**BELL BEND NUCLEAR POWER PLANT
RESPONSE TO ENVIRONMENTAL
INFORMATION NEEDS, SECOND SUBMITTAL
BNP-2010-173 Docket No. 52-039**

**Information Needs Responses
Alternative Sites Audit
June 15-17, 2010
Bell Bend Nuclear Power Plant
Luzerne County Pennsylvania**

Figure 9.3-21. Montour Site Vicinity Map

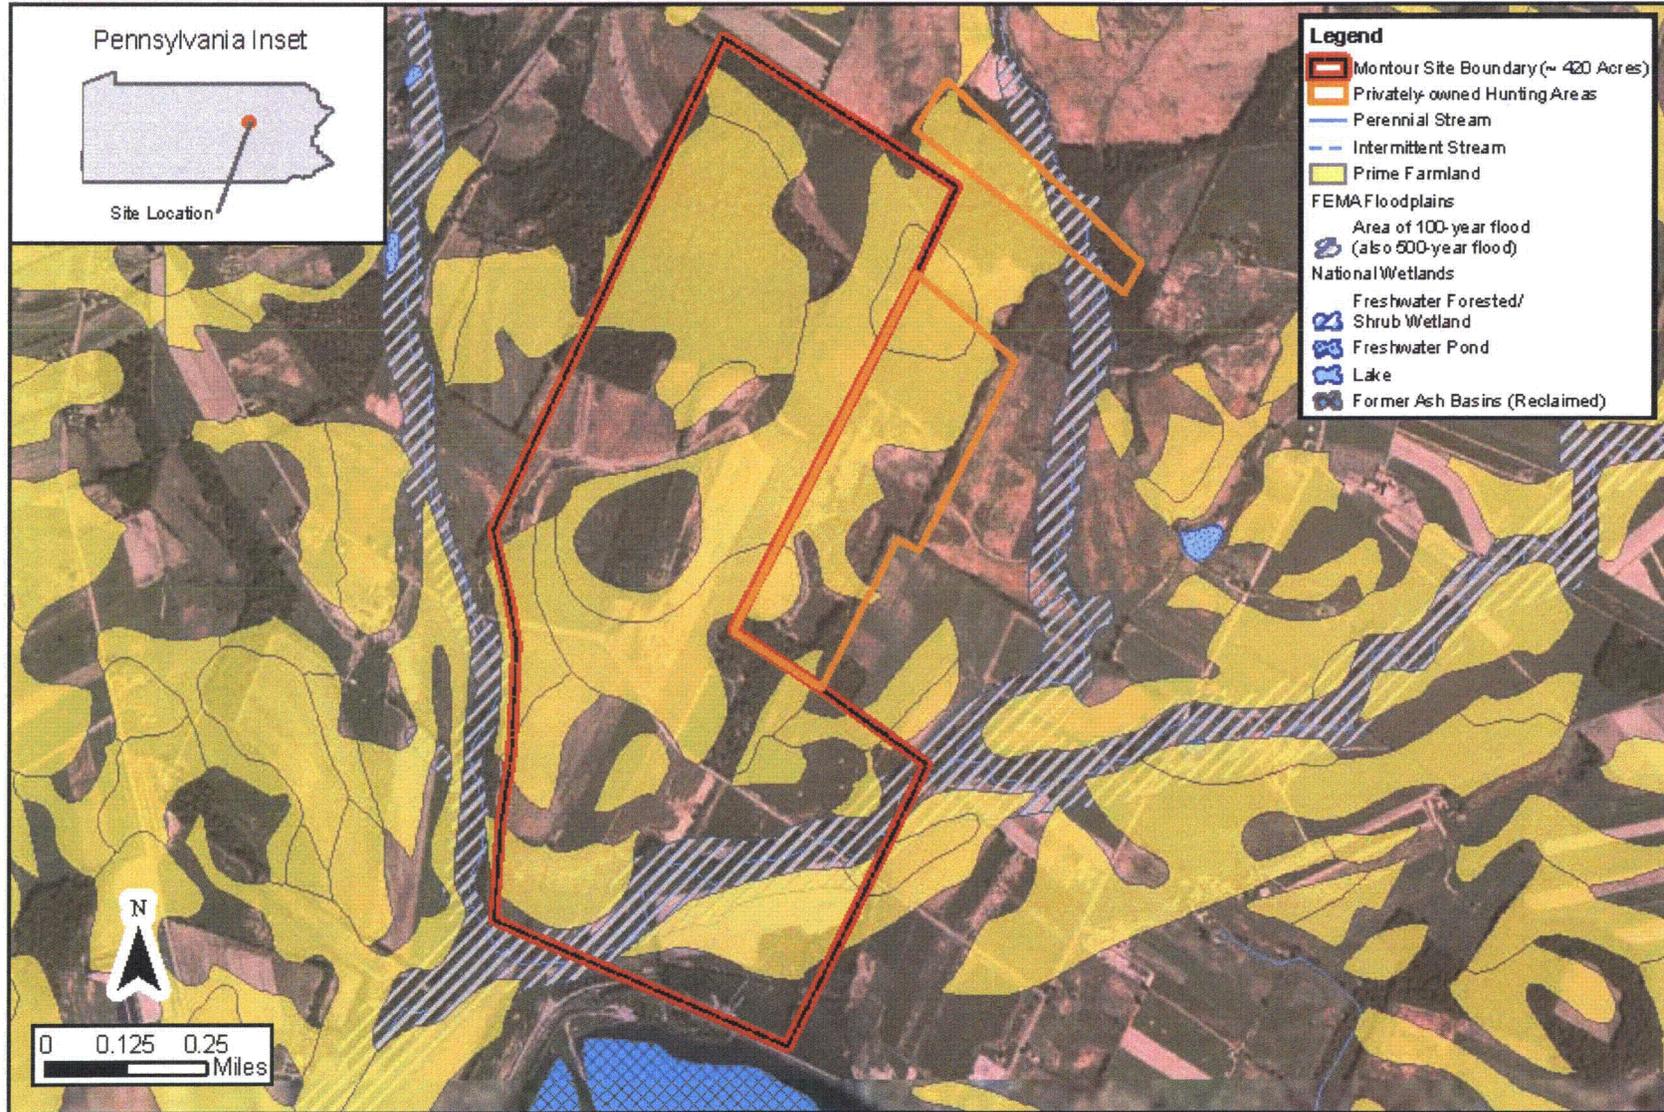
Information Needs Text: Provide a knowledgeable expert who can provide a concise description of the water body located at the southeast corner of the proposed Montour site boundary.

Response: A subject matter expert will be available to provide a concise description of the water body located at the southeast corner of the proposed Montour site boundary. The East Branch of the Chillisquaque Creek runs east-west through the southern portion of the Montour site (onsite). The former ash basin of the Montour Coal Plant appears in some older aerial and topographic figures, including ER Figure 9.3-21, Montour Site Vicinity Map, as a water body/lake just to the southeast of the Montour site boundary. This former ash basin has been reclaimed, filled and reseeded, and is now a grass-covered field. There is no other water body located at the southeast corner of the proposed Montour site boundary. In a future revision of ER Section 9.3, Figure 9.3-21 will be revised to clarify that the apparent water body just outside the Montour site boundary is not a water body but a reclaimed former ash pond.

BBNPP COLA ER Section 9.3.2.2.5 will be revised and Figure 9.3-21 replaced, as follows, in a future revision of the COLA:

The former ash basin of the Montour Coal Plant appears in some older aerial and topographic figures, including ER Figure 9.3-21, Montour Site Vicinity Map, as a water body/lake just to the southeast of the Montour site boundary (see ER Figure 9.3-21 Legend). This former ash basin has been reclaimed, filled and reseeded, and is now a grass-covered field. There is no other water body located at the southeast corner of the proposed Montour site boundary.

Figure 1. Qualitative assessment of gas recoverability from Devonian shales of the Appalachian basin (from Milici and Swezey, 2006)

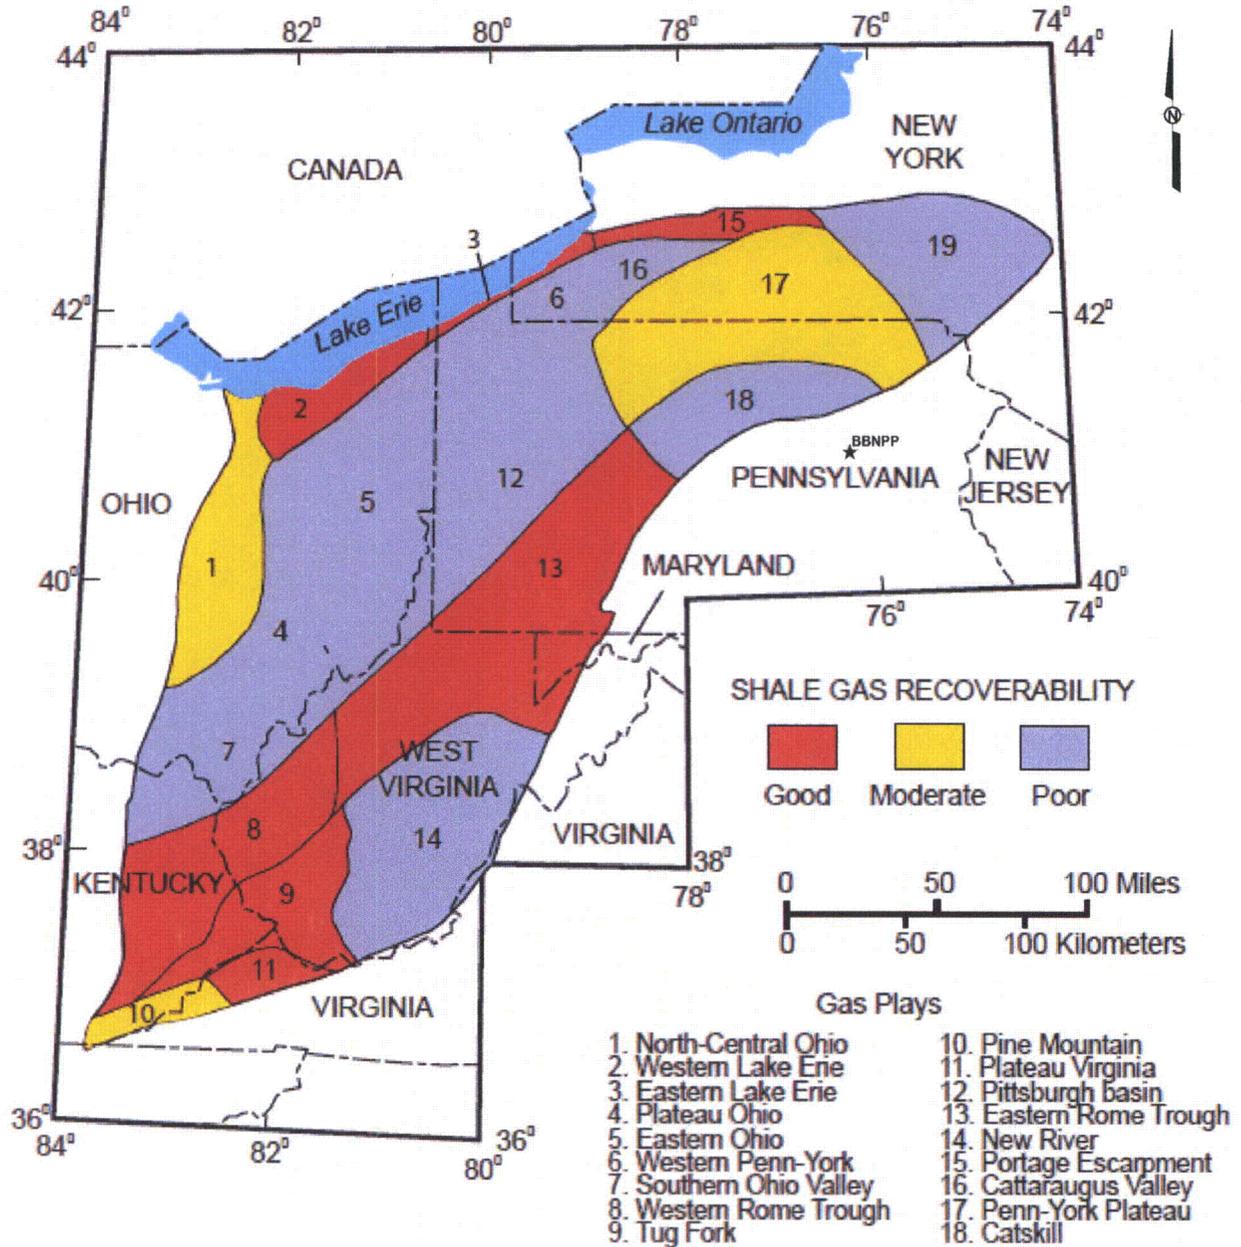
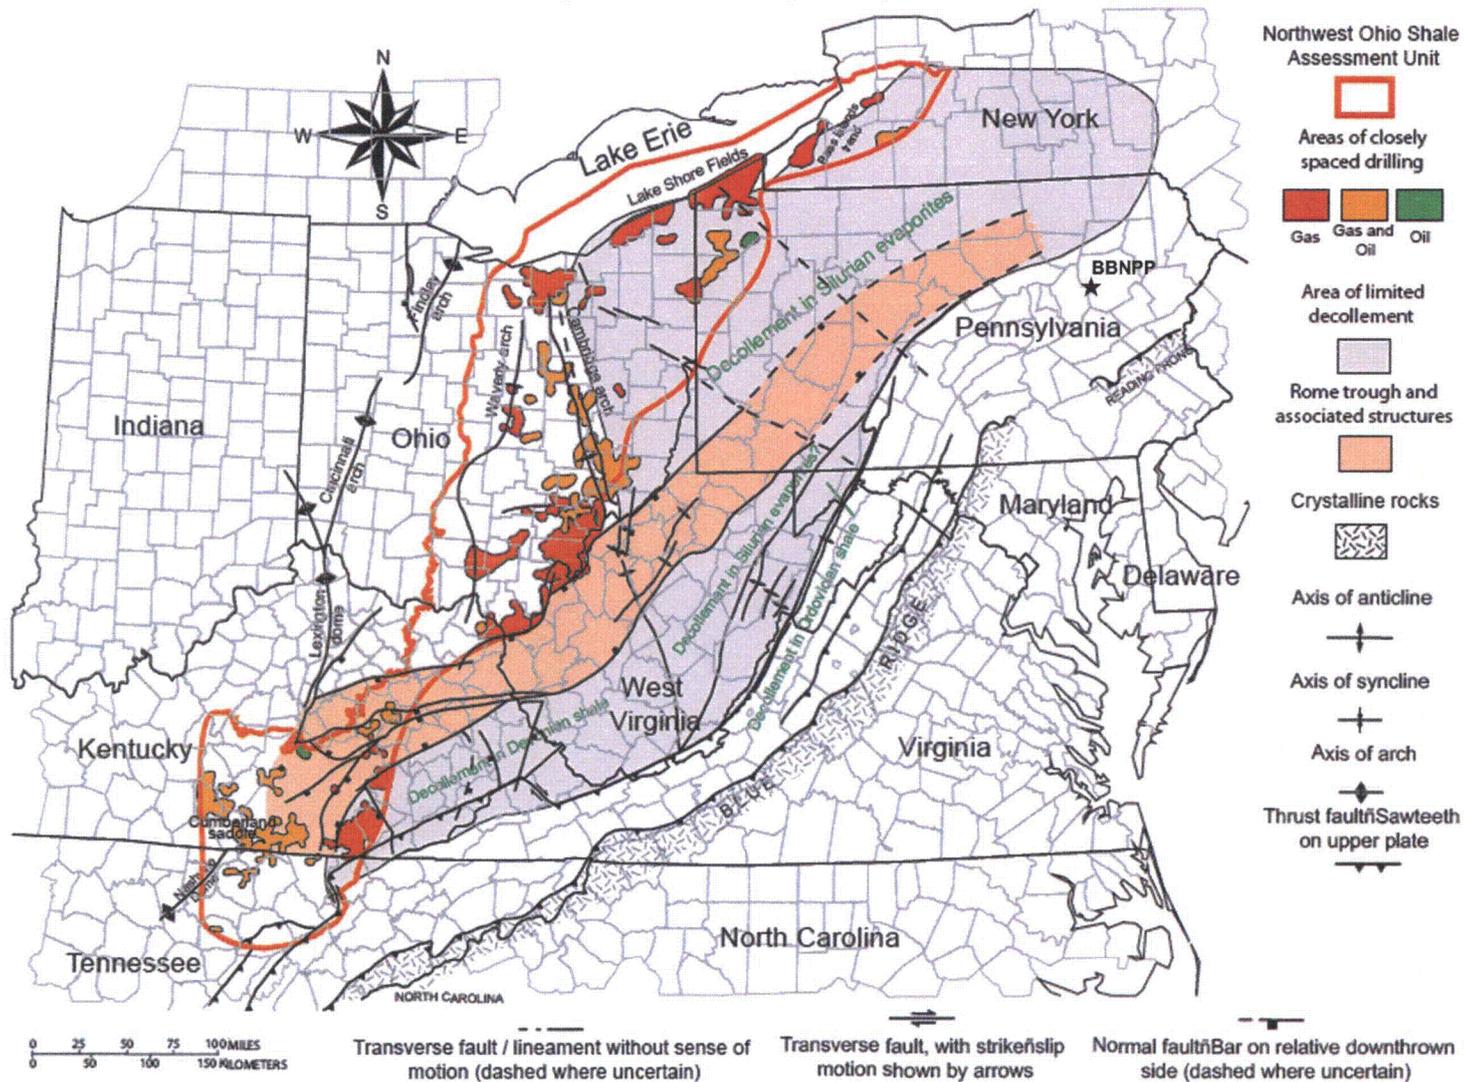
RAI question GEO 2.6-1 previously raised the issue of natural gas development in the area of the Bell Bend site as follows: "Provide a characterization of the economic viability of extracting natural gas in the Devonian period Marcellus shale that underlies the proposed BBNPP Site."

"Pennsylvania is a major producer of oil and gas in the eastern U.S. However, most of the oil and gas is being produced in western, northwestern, and northern Pennsylvania (see Figures 1 and 2). Recently, there has been great interest in the Marcellus and other Devonian shales in Pennsylvania and surrounding states (Milici and Swezey, 2006; Sumi, 2008). A new surge in drilling has occurred due to the rise in gas prices and the improvement of drilling technology. Overall, the areas of greatest development are north and northwest of the BBNPP Site (outside of Columbia and Luzerne counties), as shown on Figures 1 and 2.

Records obtained from the Pennsylvania Department of Environmental Protection (PADEP), Bureau of Oil and Gas Management show that there has been no recent oil or gas drilling/development activity in Columbia County, and that only 10 wells have been drilled in Luzerne County (see Figure 3). Out of these 10 wells, only one is active. Thus, the potential to find oil or gas deposits of economic value are very low for the area immediately surrounding the BBNPP."
